**PLANNED UNIT DEVELOPMENT  
& SUBDIVISION STAFF REPORT****Date: December 5, 2013****DEVELOPMENT NAME**

Airport-Providence Subdivision

Planned Unit Development Approval to amend a previously approved Planned Unit Development to allow shared access between multiple building sites, and Subdivision approval to create three legal lots of record from an existing metes and bounds parcel.

# SITE PLAN

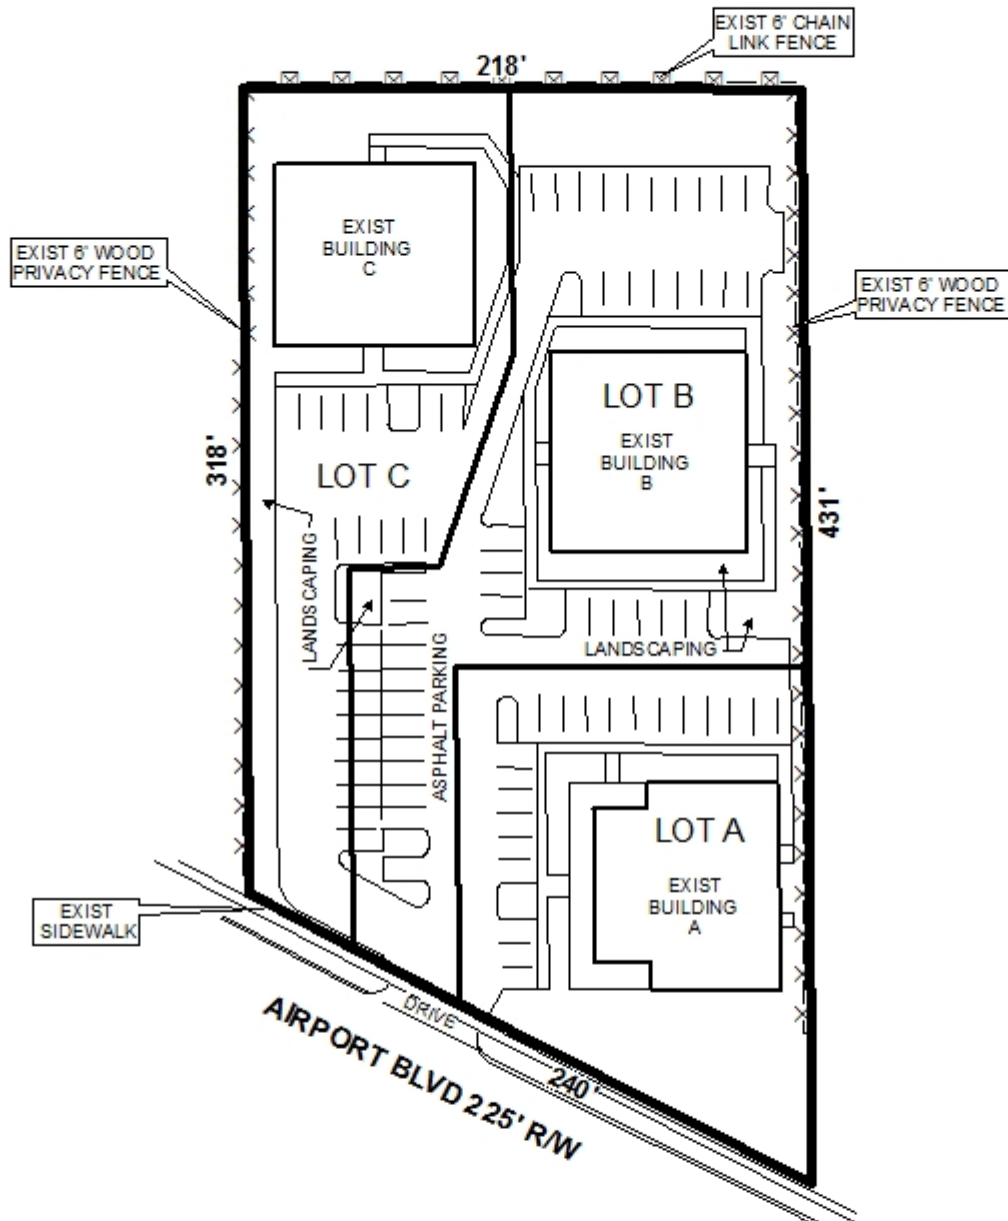
The proposed lots, as depicted, meet the minimum size and frontage requirements as regulated by the Subdivision Regulations. The 25-foot minimum building setback lines are not depicted; therefore, the plat should be revised to depict the 25' minimum building setback line along all lots as measured from where they are at least 60' wide. The lot area sizes in square feet are depicted in a table on the plat; this should be revised to show the lots sizes in both square feet and acres, or each lot should be labeled with such on the Final Plat, if approved.

The site was originally developed via a PUD approved in 1986, and abuts properties zoned R-1, Single-Family Residential, to the East, North and West. A recommended condition of that approval was a 10' protection buffer and a 6' high fence or wall around the North, East and West sides of the site. The existing site plan indicates a 6'-high wooden privacy fences along the East and West sides. A vegetated protective buffer is indicated along the North side as well as a chain link fence, but no privacy fence or wall is indicated. A permit was issued for the construction of a wooden privacy fence along the North side and follow-up inspections indicate the fence was completed. Therefore, the site plan should be revised to indicate the 6' high wooden privacy fence along the North property line.

An existing city standard sidewalk is indicated along the Airport Boulevard Service Road; therefore, no further public sidewalks would be required. The site plan does not indicate a dumpster or contain a note stating how trash pick-up is proposed. Therefore, the site plan should be revised to indicate a dumpster, in compliance with Section 64-4.D.9. of the Zoning Ordinance, and with a compliant sanitary sewer connection, or a note should be placed on the site plan stating that trash collection will be curb-side pick-up or private pick-up service.

It appears that the site was developed just prior to the adoption of the landscape ordinance or during its first year of implementation; however, the site plan does not depict existing landscaping areas or tree plantings. Full compliance with both landscaping area and tree plantings will not be required; however, frontage trees should be required for the site with the location to be coordinated with Urban Forestry. Also, the site plan and plat do not indicate a detention area. If a detention area is required, it should be labeled as a common area on both with a note stating that maintenance of the common area is the responsibility of the property owners.

- 1) revision of the site plan to illustrate the 25' minimum building setback line along all lots as measured from where the lots are at least 60' wide;

- 2) revision of the site plan to illustrate the existing 6' high wooden privacy fence along the rear (North) property line;
- 3) revision of the site plan to provide a dumpster, in compliance with Section 64-4.D.9. of the Zoning Ordinance, and with a compliant sanitary sewer connection, or the placement of a note on the site plan stating that trash collection will be curb-side or via private pick-up service;

- 4) revision of the site plan to depict compliance with frontage trees, to be coordinated with Urban Forestry;
- 5) labeling of any required detention area as common area and the placement of a note on the site plan stating that the maintenance of the common area is the responsibility of the property owners;
